## **233 JOINT VENTURE SUBDIVISION**

APPLICATION NUMBER 20 DATE March 6, 2008

REQUEST Subdivision

# DETAIL SITE PLAN

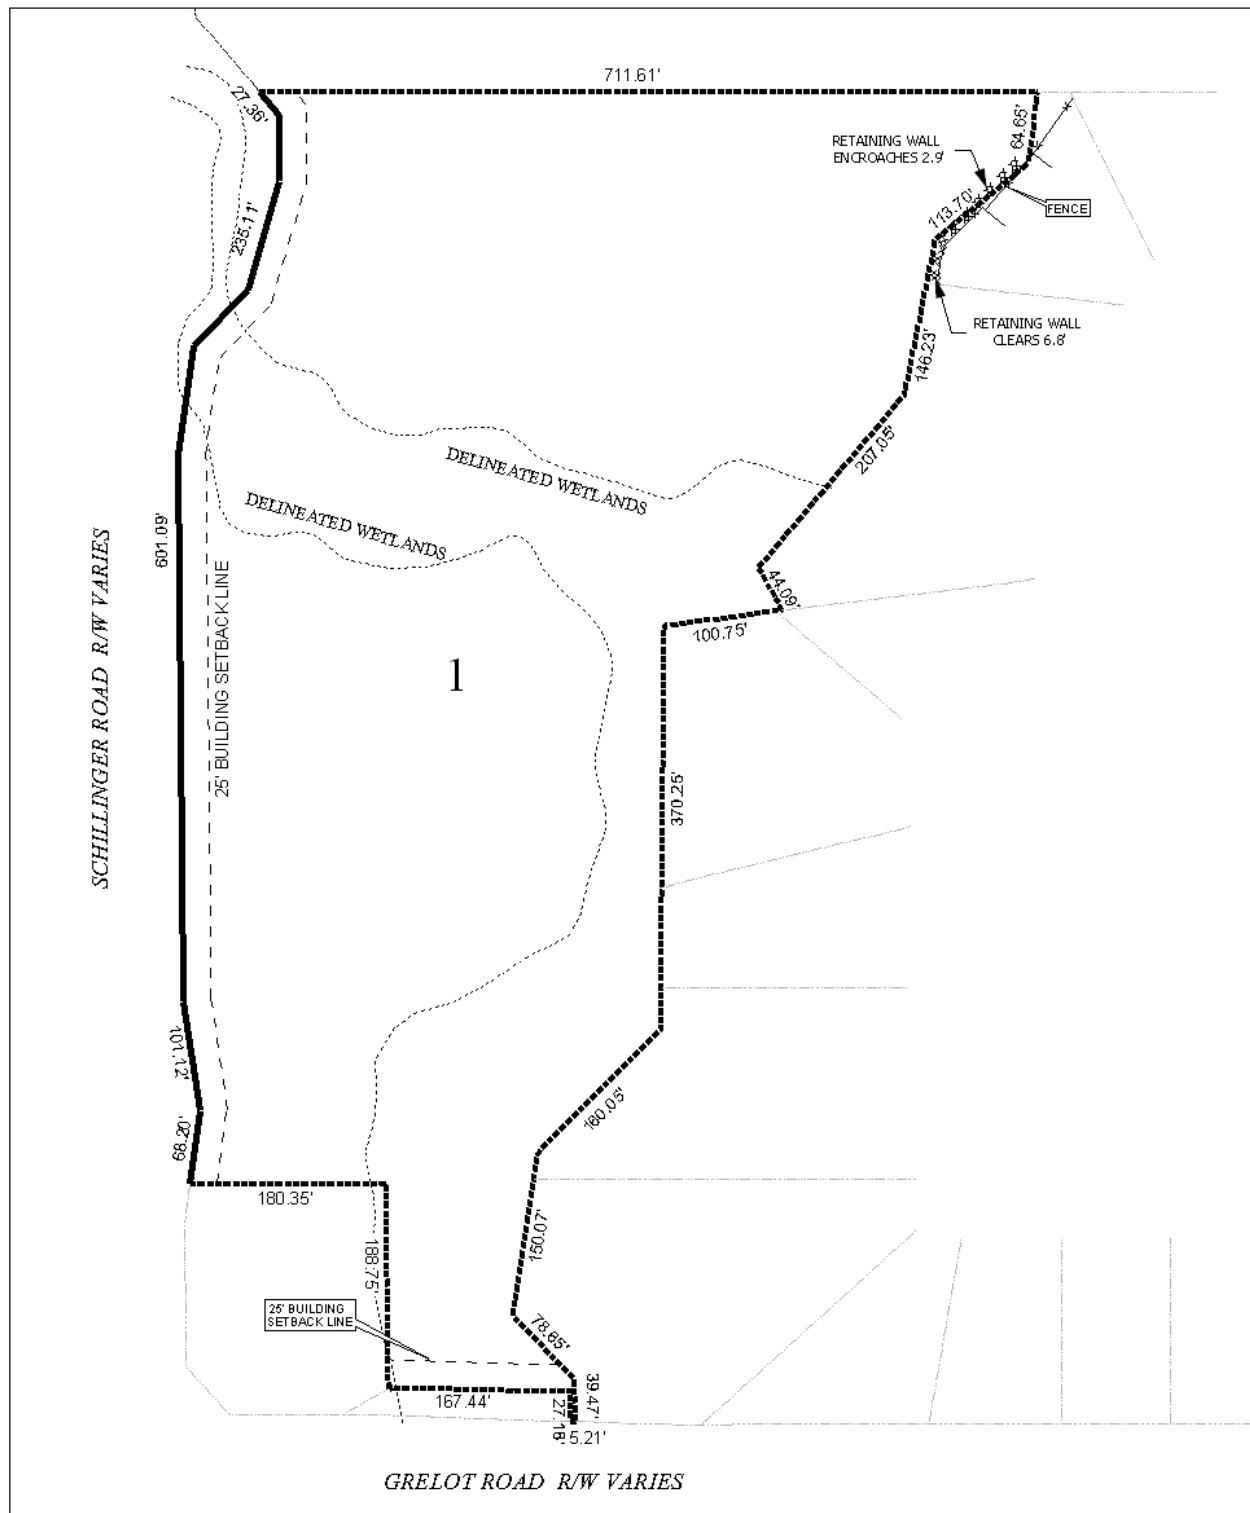
The plat illustrates the proposed 1 lot, 12.4 ± acre subdivision which is located on the East side of Schillinger Road, 190' + North of Grelot Road, extending to the North side of Grelot Road, 180' + East of Schillinger Road. The applicant states that the subdivision is served by public water and sanitary sewer facilities.

The site fronts onto Schillinger Road South and Grelot Road, both proposed major streets. Specific right-of-way dimensions are not provided on the plat, however, the applicant should ensure that sufficient right-of-way to provide 50 feet, as measured from the centerline of each road exists, or the plat should be revised to dedicate the necessary right-of-way.

As both Schillinger Road South and Grelot Road are proposed major streets, access management is a concern. The site has approximately 1000 feet of frontage onto Schillinger Road South, and approximately 240 feet of frontage onto Grelot Road. Each road frontage includes areas that are encumbered by 2<sup>nd</sup> Creek, thus the Schillinger Road frontage should be limited to a maximum of three (3) curb-cuts, and the Grelot Road frontage should be limited to one (1) curb-cut. The size, design and location of any curb-cuts are to be approved by the Mobile County Engineering Department.

The plat illustrates that wetlands are present on the property, thus some parts of the site may be considered environmentally sensitive. Therefore, approvals from federal, state, and local agencies will be required for potential floodplain and wetland issues prior to the issuance of any permits or land disturbance activities.

- 1) Placement of a note on the final plat stating that the lot is limited to three (3) curb-cuts onto Schillinger Road South and one (1) curb-cut onto Grelot Road, with the size, design and location of all curb-cuts to be approved by the Mobile County Engineering Department;

- 2) Dedication and labeling of right-of-way sufficient to provide 50-feet as measured from the centerline along both Schillinger Road South and Grelot Road, if necessary to meet minimum requirements;

- 3) Depiction of the 25-foot minimum building setback line on the final plat, as depicted on the preliminary plat;
- 4) Placement of a note on the final plat stating that the development will be designed to comply with the storm water detention and drainage facility requirements of the City of Mobile storm water and flood control ordinances, and requiring submission of certification from a licensed engineer certifying that the design complies with the storm water detention and drainage facility requirements of the City of Mobile storm water and flood control ordinances prior to the issuance of any permits. Certification is to be submitted to the Planning Section of Urban Development and County Engineering;

- 6) Placement of a note on the plat stating that approval of all applicable Federal, state and local agencies is required for wetland and floodplain issues, if any, prior to the issuance of any permits or land disturbance activities;

- 7) The labeling of all lots with their size in square feet, as depicted on the preliminary plat; and
- 8) Placement of a note on the final plat stating that any lots which are developed commercially and adjoin residentially developed property must provide a buffer, in compliance with Section V.A.7 of the Subdivision Regulations.
